COUNCIL ASSESSMENT REPORT

Panel Reference	PPSSCC-392
DA Number	DA/737/2022 PAN-248715
LGA	City of Parramatta Council
Proposed Development	Demolition of existing structures and construction of a mixed-use development over two levels of basement parking. The development comprises of retail premises, business/office premises; neighbourhood shops, a pub and a childcare centre with associated landscaping, drainage works and signage. The application is Nominated Integrated development pursuant to the Water Management Act 2000.
Street Address	32-48 Silverwater Road and 1-17 Grey Street, SILVERWATER Lot 1 DP 90071 Lot 1 and 2 DP 1110059 Lot 5, 6 and 7 DP 89550 Lot 8, 9, 10, 11, 14, 15, 16 and 17 DP 979426 Lot 13 DP 75209 Lot 12 DP 76894 Lot 7 DP 77341
Applicant Owner	CK Design Pty Ltd Sonsari Pty Ltd
Date of Lodgement	16 September 2022
Number of Submissions	2 unique submissions (1 submission in support of the application)
Recommendation	Refusal

Regional Development Criteria	General Development >\$30 million
List of All Relevant s4.15 Matters	<ul style="list-style-type: none"> • Environmental Planning and Assessment (EP&A) Act 1979 • EP&A Regulations 2021 • State Environmental Planning Po

Figure 5. Level 2 of the proposed development

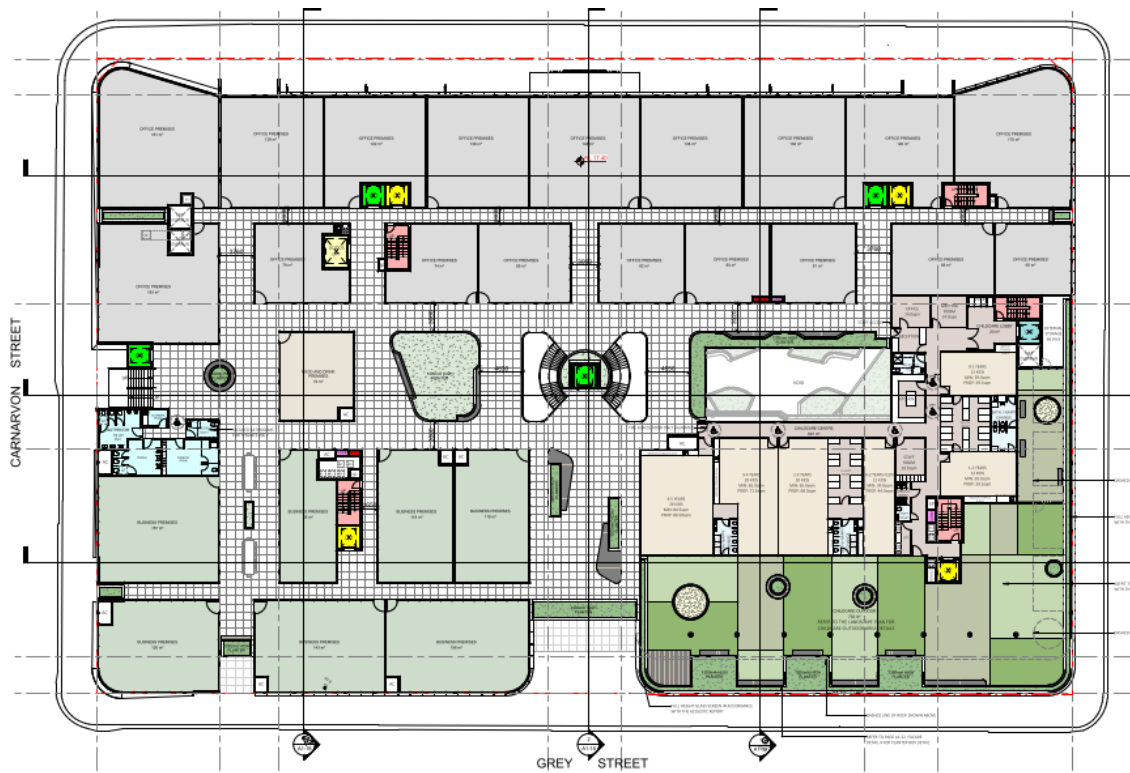
Note: The 'opening' on the roof is not open, but is enclosed by a glass enclosure for weather protection and is unlike the fully opened roof of the development in *Danks St v City of Sydney (2015)*

Council's request to amend the plans to comply with the maximum FSR of 2:1 have not been addressed. The application also did not submit a Clause 4.6 variation to Clause 4.4 – FSR. Accordingly, an assessment of the departure to Clause 4.4 – FSR under the provisions of Clause 4.6 cannot be undertaken. Given this, the variation to the FSR and the proposal is not supported.
